AS-BUILT BASELINE MONITORING REPORT

KEY MILL MITIGATION SITE

RE: Task 6 – Final As-built Baseline Monitoring Report
Key Mill Mitigation Site, Surry County
Yadkin River Basin – HUC 03040101
DMS Project ID No. 100025 / DEQ Contract #7180

DMS comment: There was considerable storm damage caused to the site during the winter/spring 2020. Please include a brief discussion regarding the impact and changes to the timeline this had on construction, repairs and asbuilt/MY0 data collection that followed.

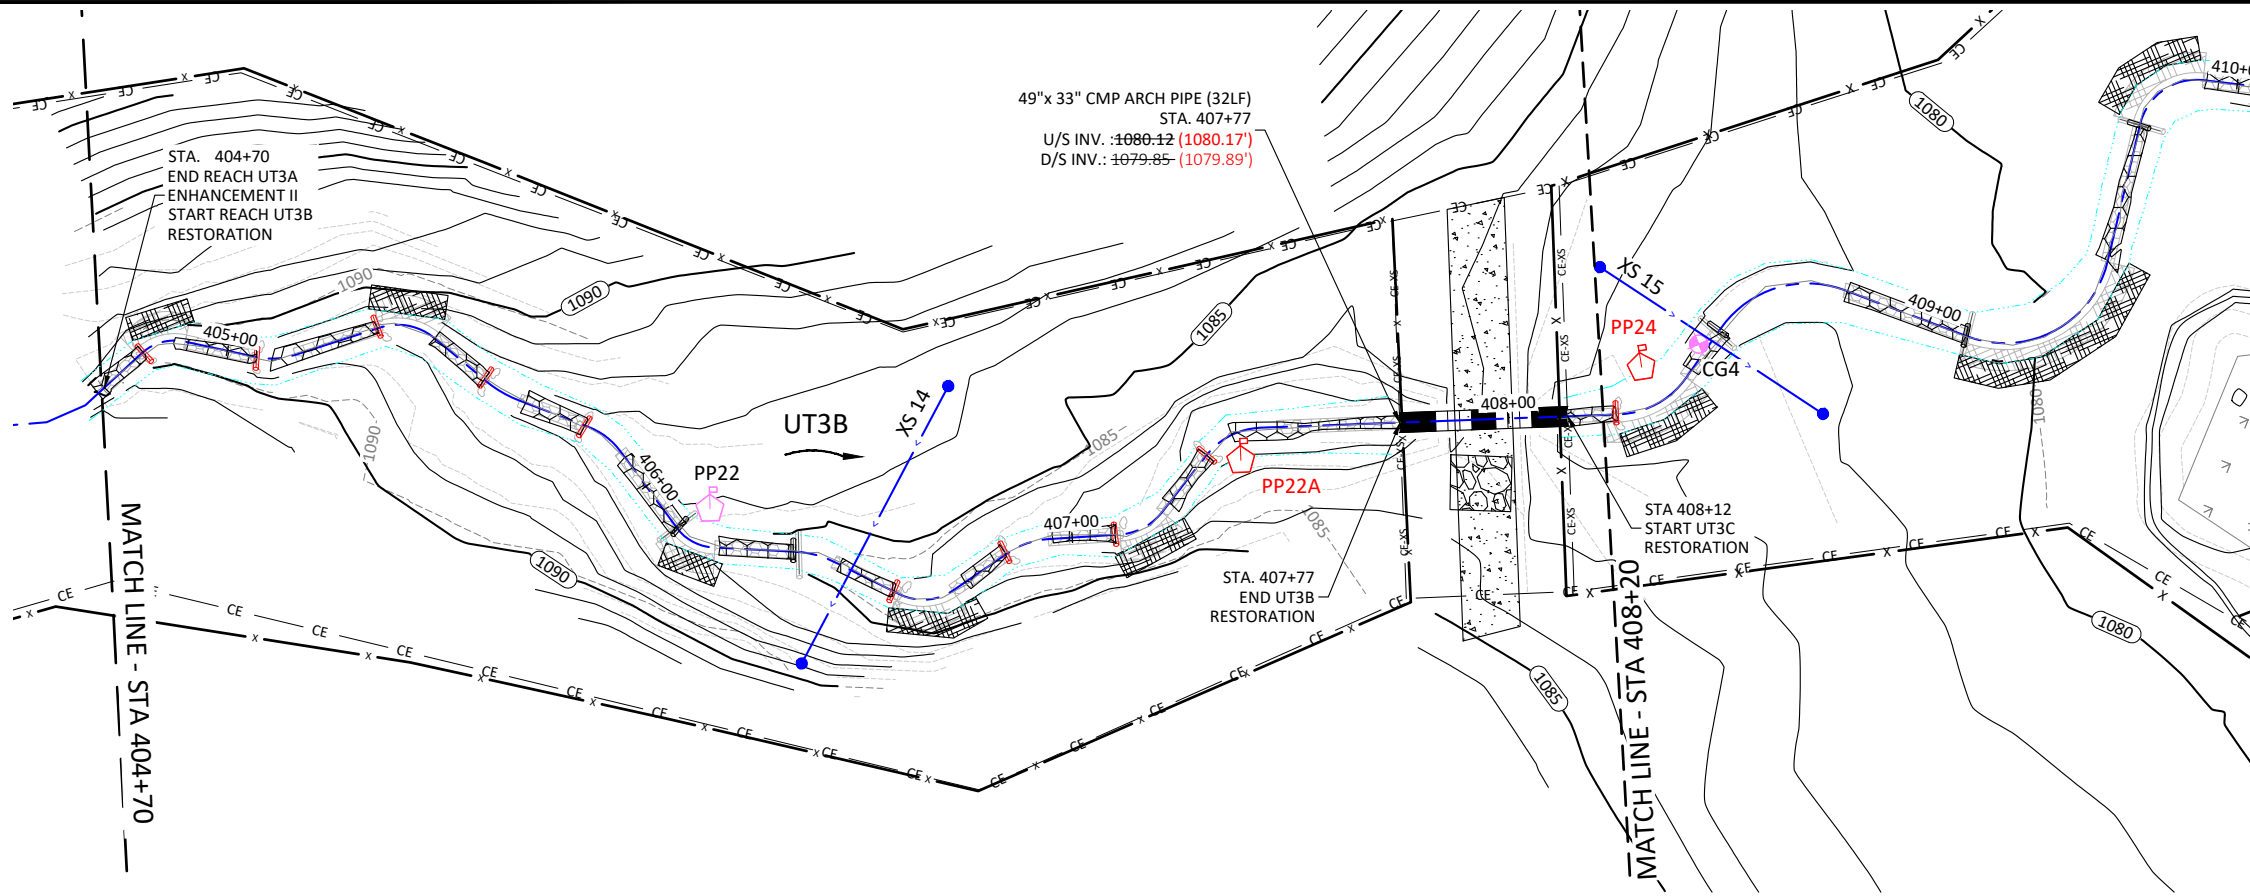
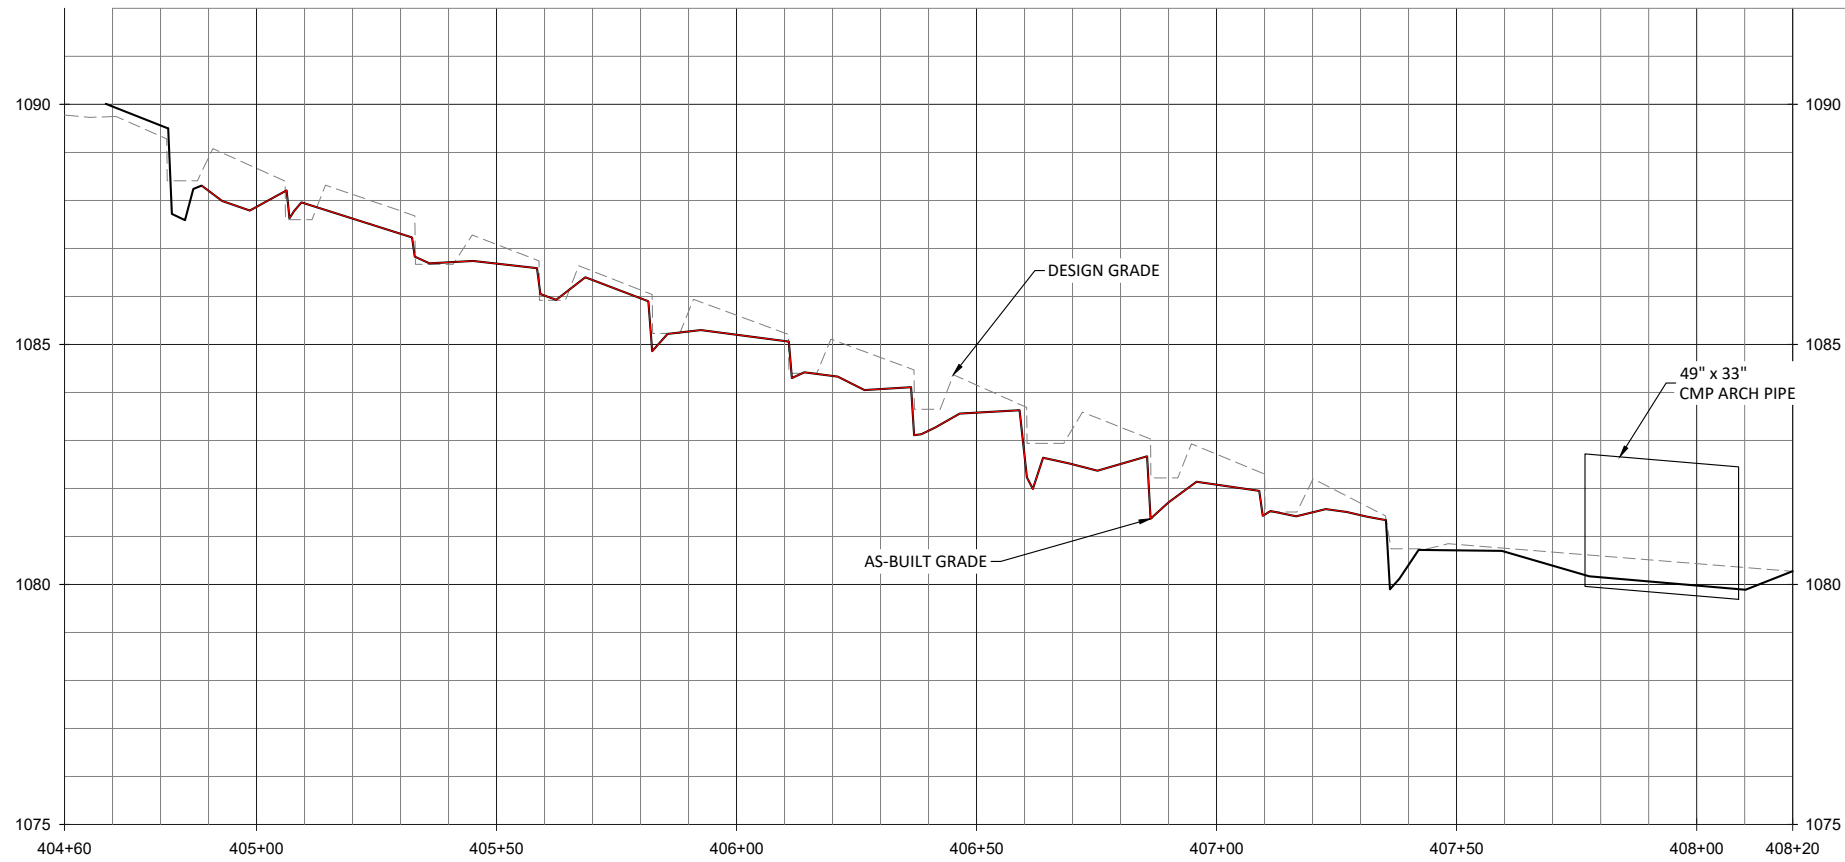
- NOTE:**
1. STA. 404+82, 405+06, 405+32, 405+58, 405+82, 406+59, 406+85, 407+09 AND 407+35: ROCK SILLS REPLACED WITH LOG SILLS DUE TO LOCAL MATERIAL AVAILABILITY AND SIMILAR FUNCTIONALITY.
 2. STA. 404+89 - 407+35: RIFFLE ELEVATIONS ADJUSTED DUE TO THE UPSTREAM TIE IN ELEVATION BEING CHANGED DUE TO FIELD CONDITIONS.
 3. STA. 407+41: PHOTO POINT 22A WAS ADDED AFTER THE SURVEY WAS COMPLETED AT THE REQUEST OF DMS TO CAPTURE A DOWNSTREAM VIEW OF THE CULVERT CROSSING.
